Product Change Notification / JAON-04FTWF456

CCB 4540 Initial Notice: Qualification of a new lead frame design for selected products available in 8L SOIC package using 8900NC die attach and palladium coated copper with gold flash (CuPdAu) bond wire material assembled at MMT assembly site.

PCN # JAON-04FTWF456

Pre Change

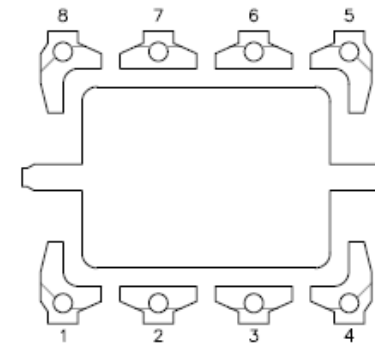
LF STRIP DENSITY: x140
LF PAD SIZE: 95x130 mils
LEAD LOCK: NO

Post Change

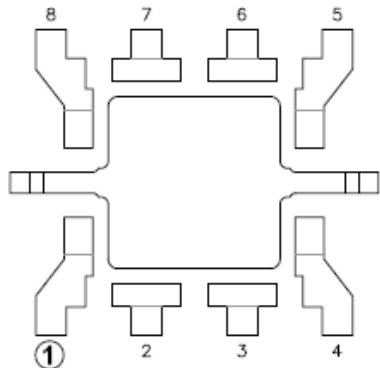
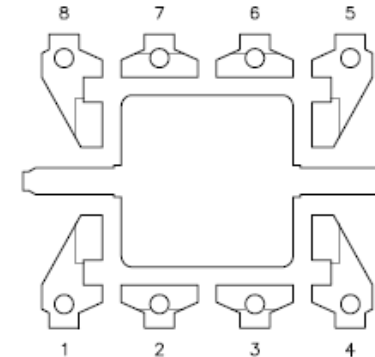
LF STRIP DENSITY: x320
LF PAD SIZE: 95x130 mils
LEAD LOCK: YES

LF STRIP DENSITY: x320
LF PAD SIZE: 90x90 mils
LEAD LOCK: YES
